ORIGINATION FORM

Proposed Revisions to a Standard Plans Index
(Please provide all information — Incomplete forms will be returned)

Index Number: 515-062
Sheet Number (s): 6
Index Title: Pedestrian/Bicycle Railing (Aluminum)

PEDESTRIAN/BICYCLE RAILING (ALUMINUM)

TYPE 2 - CHAIN-LINK (Continuous Infill Panel)

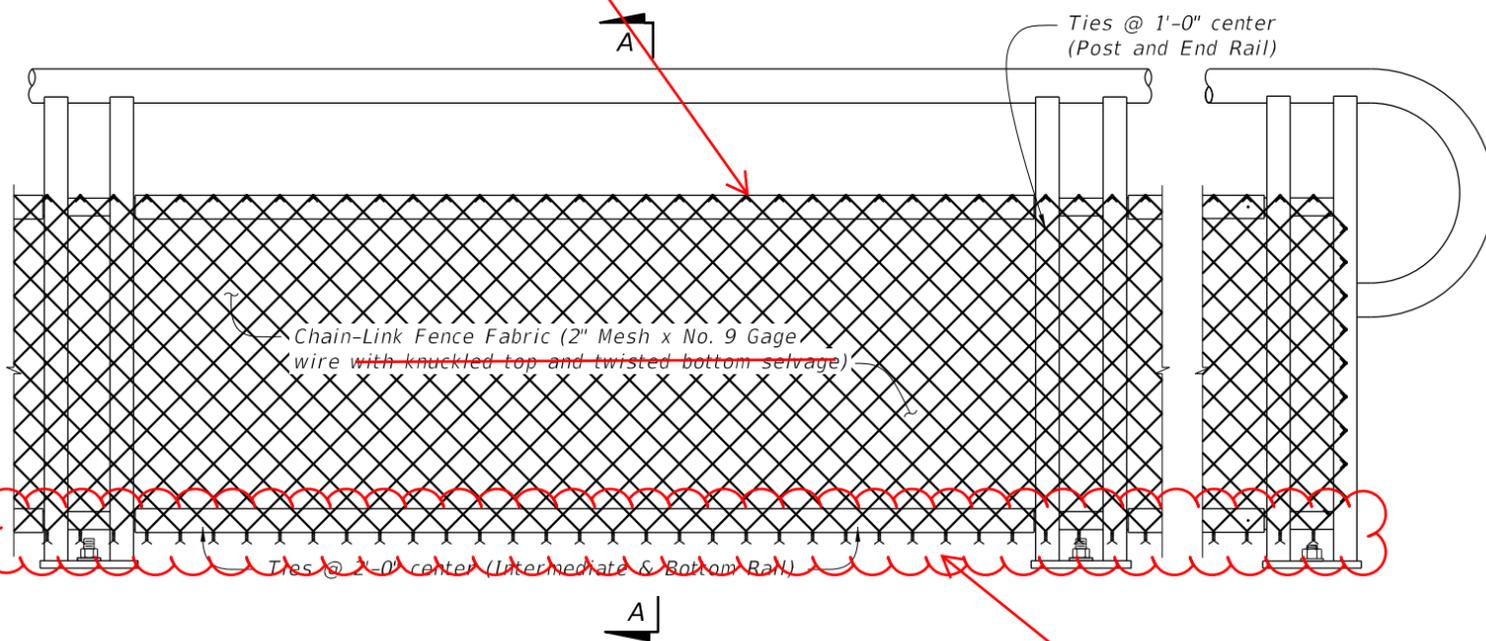
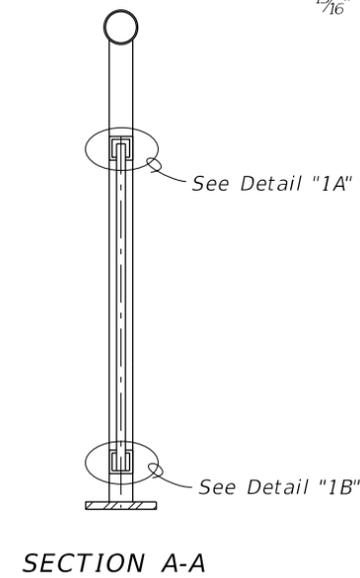
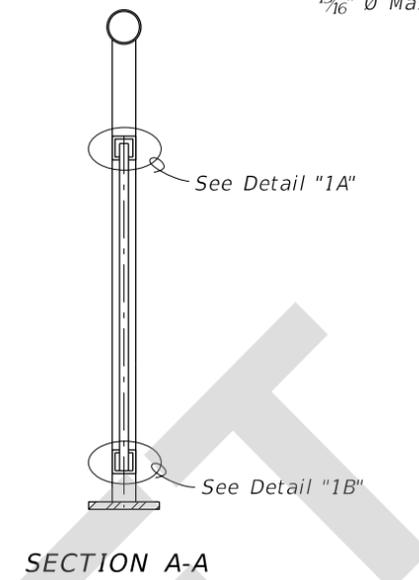
Sheet 6- Added knuckled selvage as an option to the chain-link railing option

The selvage requirements detailed on Index 515-062 were based on a conservative approach to secure the bottom edge. Using knuckle selvage top and bottom would be acceptable.

Knuckled Selvage (Typ.)

Redraw as knuckled

Knuckled Selvage (Typ.)

TABLE 2 - CHAIN-LINK PANEL COMPONENT MATERIALS		
COMPONENT	ASTM	COMPONENT INFORMATION
Chain-Link Fence Fabric (2" mesh with knuckled top and bottom selvage)	A392	Zinc-Coated Steel - No. 9 gage (coated wire diameter), Class 2 Coating
	A491	Aluminum-Coated Steel - No. 9 gage (coated wire diameter)
	F668	Polyvinyl Chloride (PVC) Coated Steel - No. 9 gage Zinc-Coated Wire (metallic-coated core wire diameter) ~ See Plans for specified color of PVC.
Tie Wires	F626	Zinc-Coated Steel Wire - No. 9 gage with coating to match Chain-Link Fence Fabric.
Tension Bars	F626	3/16" (min. thickness) x 3/4" (min. width) x 2'-3' (min. height) Steel Bars
Miscellaneous Fence Components	F626	Zinc-Coated Steel
